Agenda
Village of Arlington Heights
Design Commission
Buechner Room, 1st Floor

MINUTES OF
THE VILLAGE OF ARLINGTON HEIGHTS
DESIGN COMMISSION MEETING
HELD AT THE ARLINGTON HEIGHTS MUNICIPAL BUILDING
33 S. ARLINGTON HEIGHTS RD.
MARCH 14, 2017

Department: Planning & Community Development

NORTH ELEVATION (FRONT)
SCALE: 1/4" = 1'-0"
3"x5" DOWN SPOUT NOT SHOWN - REFER TO ROOF PLAN

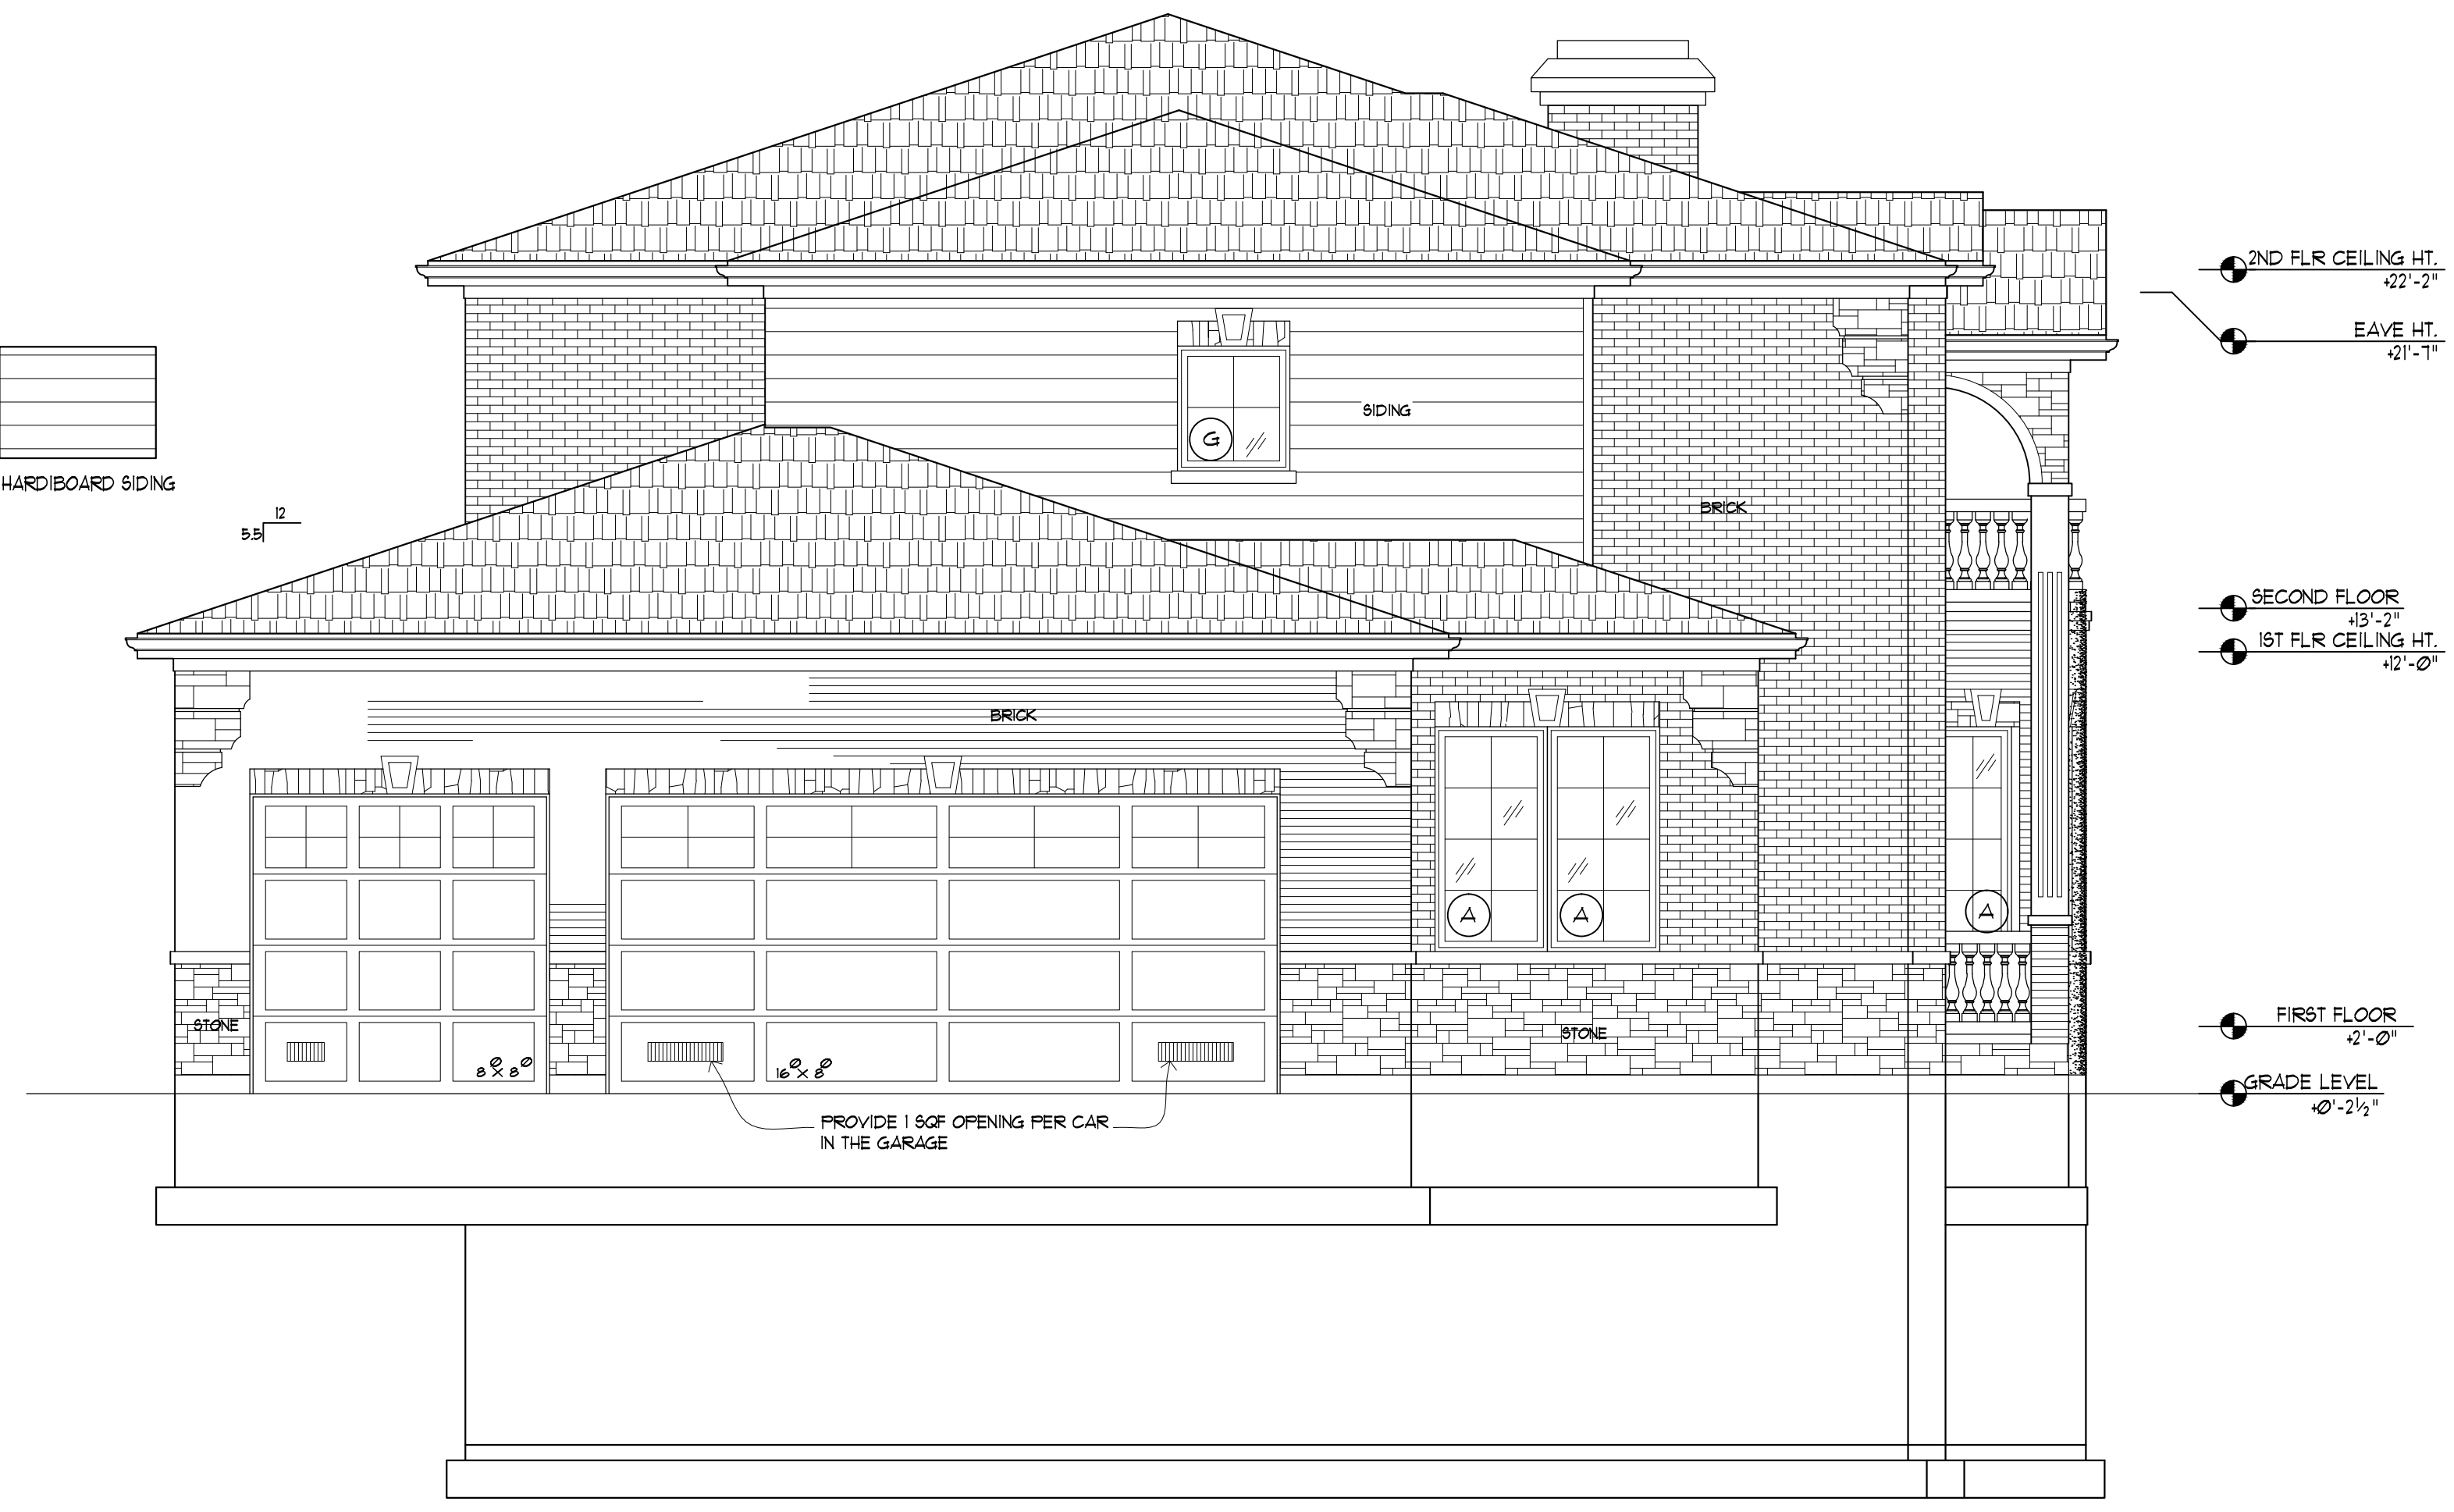
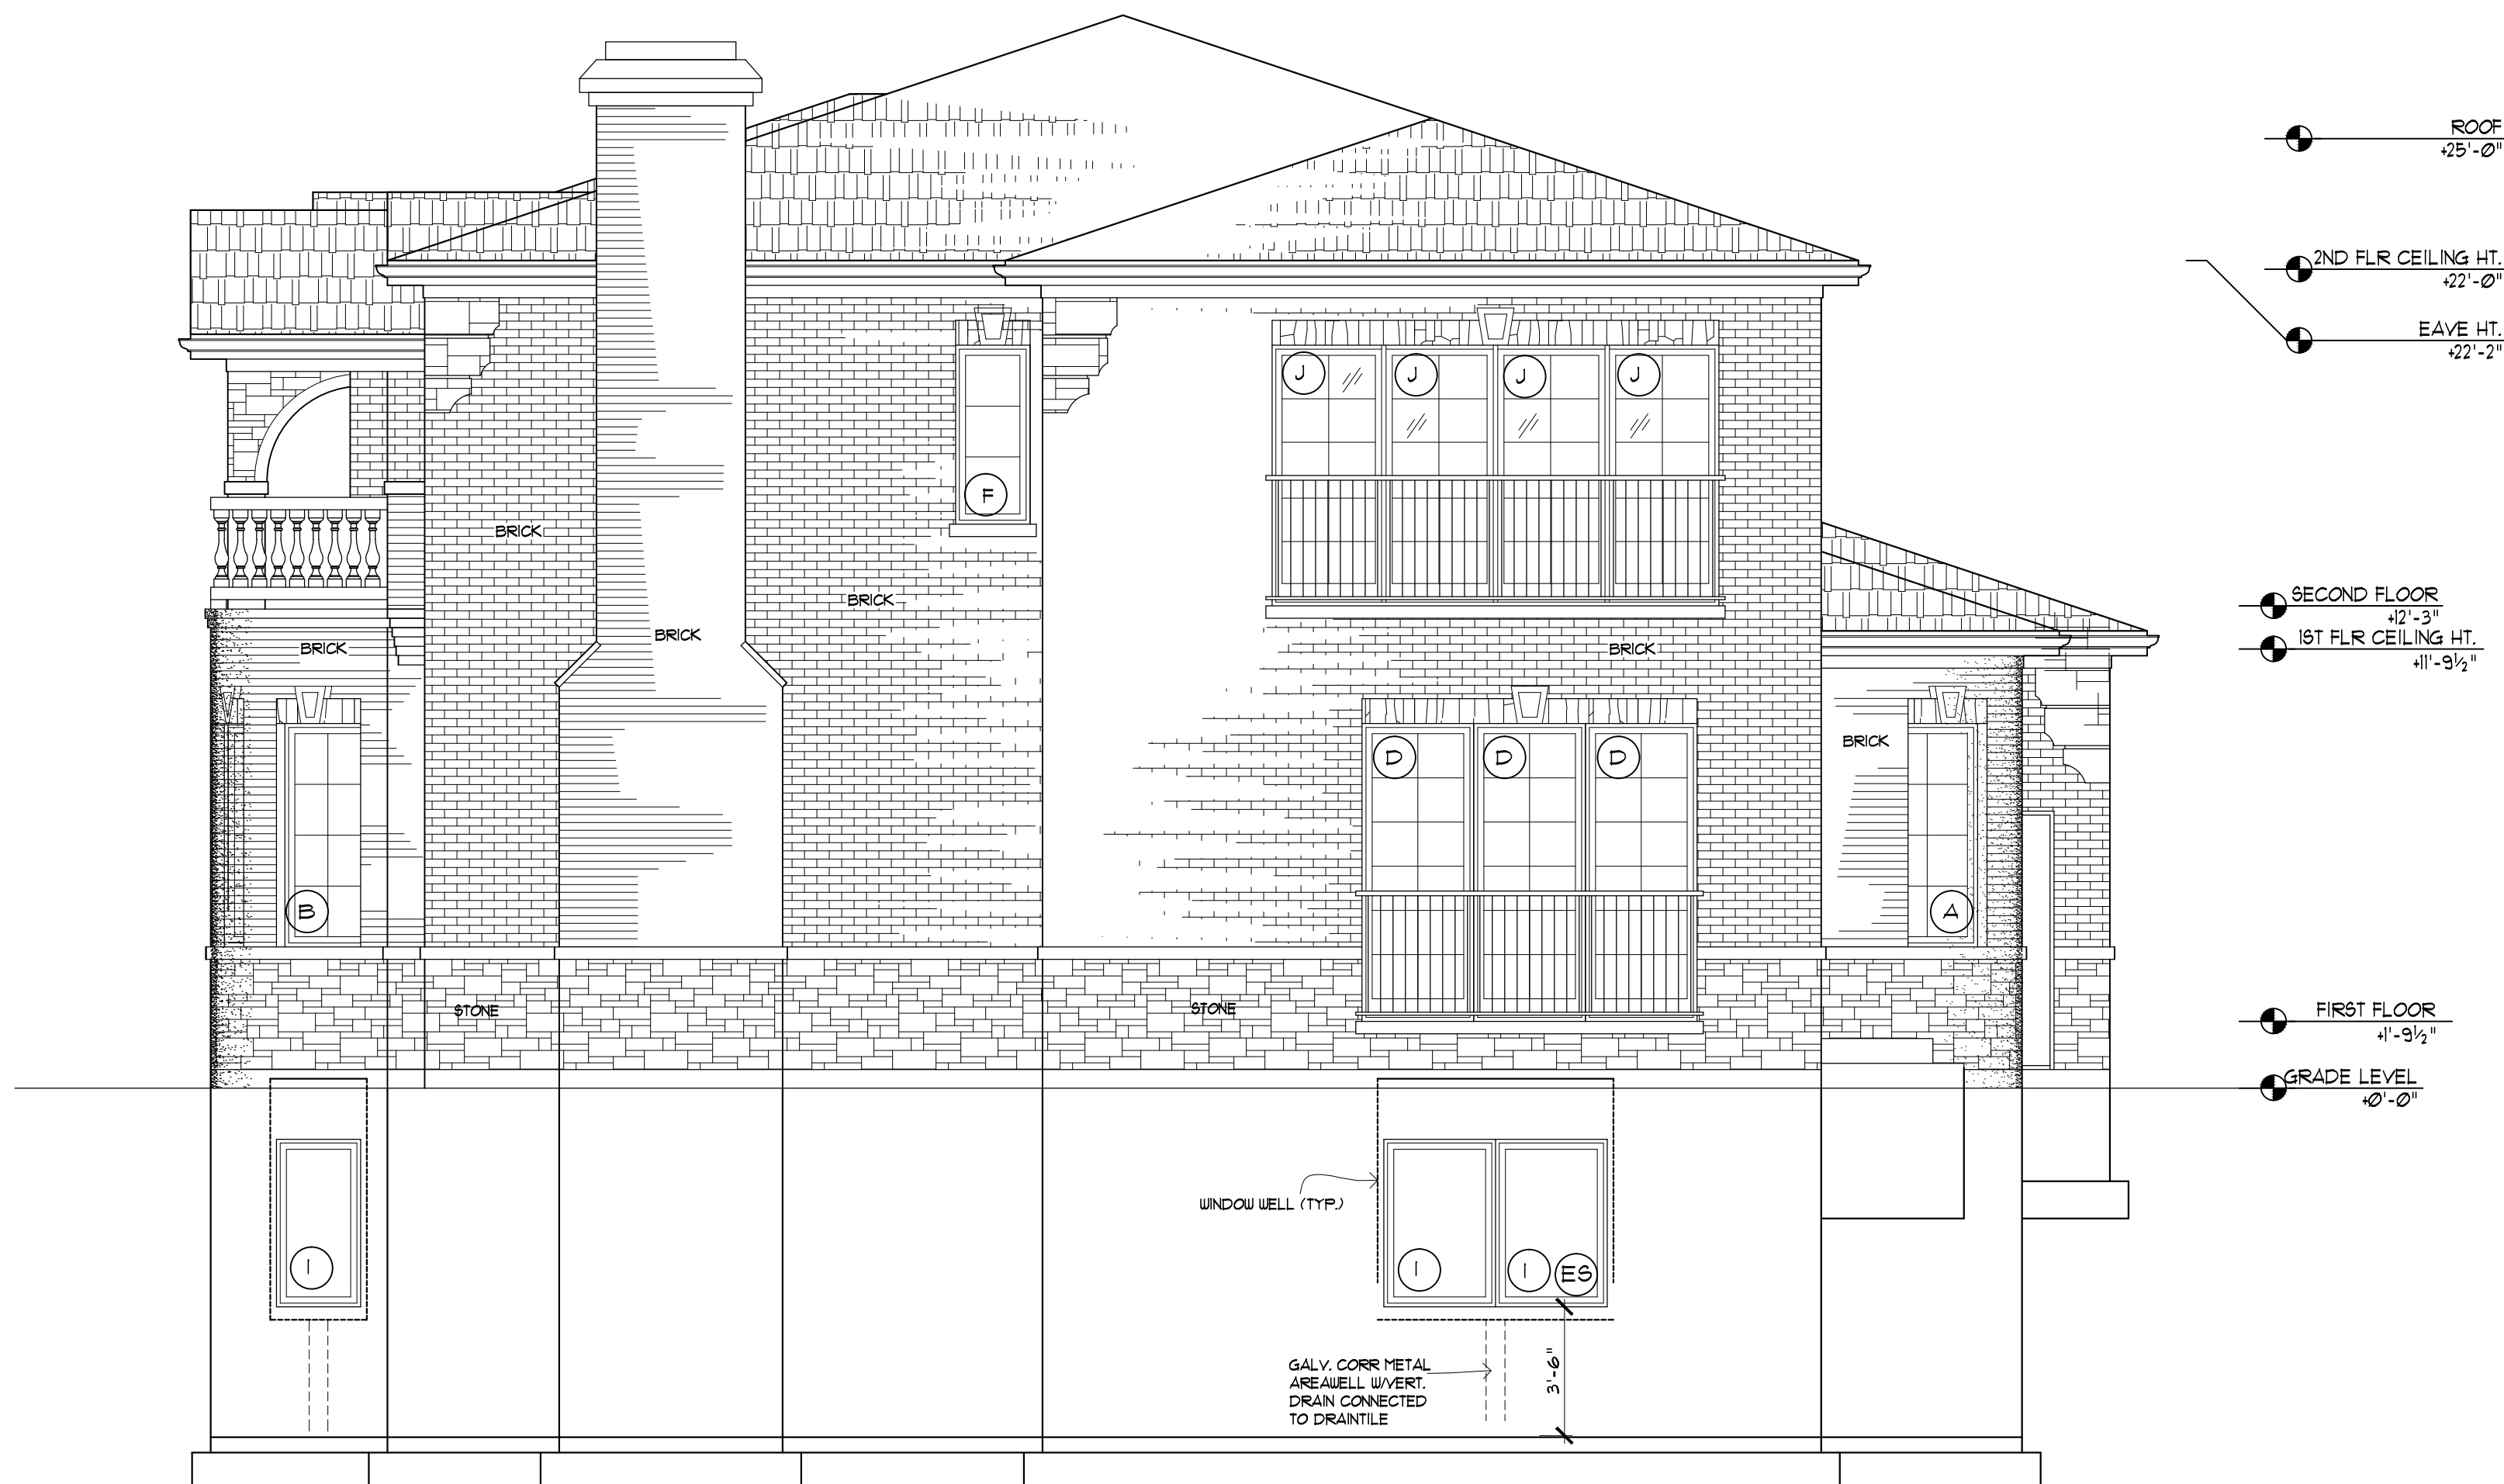
It is recommended that the Design Commission require revisions and re-review the proposed new single-family residence to be located at 905 W. Maude Avenue. This recommendation is based on the architectural plans dated 2/20/17 and received on 3/3/17, and the following:

3. Revise the scale of the front elevation to include some single story elements to fit the scale of the neighborhood.
4. This review deals with architectural design only and should not be construed to be an approval of, or to have any other impact on, any other zoning and/or land use issues or decisions that stem from zoning, building, signage or any other reviews. In addition to the normal technical review, permit drawings will be reviewed for consistency with the Design Commission and any other Commission or Board approval conditions. It is the architect/homeowner/builder's responsibility to comply with the Design Commission approval and ensure that building permit plans comply with all zoning code, building permit and signage requirements.
